Clear REC state diagram Comment #19

Natalie Wienckowski, GM

April 16&17, 2019

IEEE802.3ch Interim

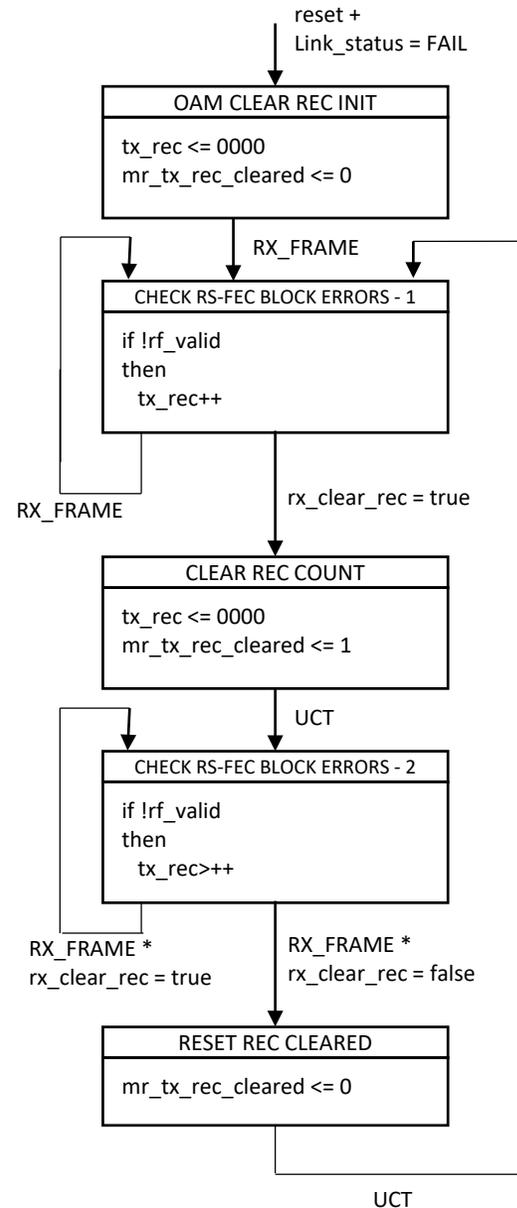
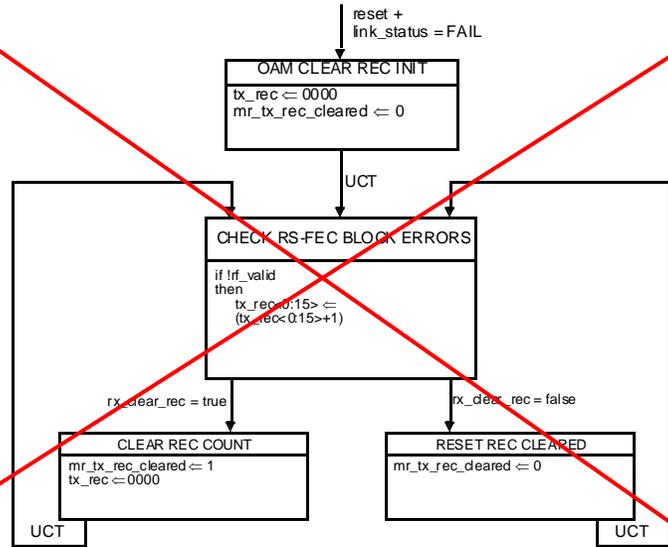
Email from William Lo: I have a question on the rx_clear_rec variable.

On page 128 it simply states “Request from the link partner to clear the REC counter”

Once this variable goes true, how does it go back to false?

We need to define this otherwise there is an infinite loop in Figure 149-24 that always clears the tx_rec.

A secondary issue is that the loops around figure 149-24 are running at infinite speed and is not paced.

I think the intention is to check the loop once per RS Frame. If we don't do this then tx_rec will keep incrementing once rf_valid is false.

This updated Figure corrects identified issues.

Transitions are now based on the reception of a Frame.

The REC counter will be cleared once per request and will start counting again. This will not be reset continually while waiting for the Link Partner to acknowledge the counter was cleared.

Once the clearing of the REC Counter is acknowledge, the counter continues to count errors and waits for a new request to clear the counter.
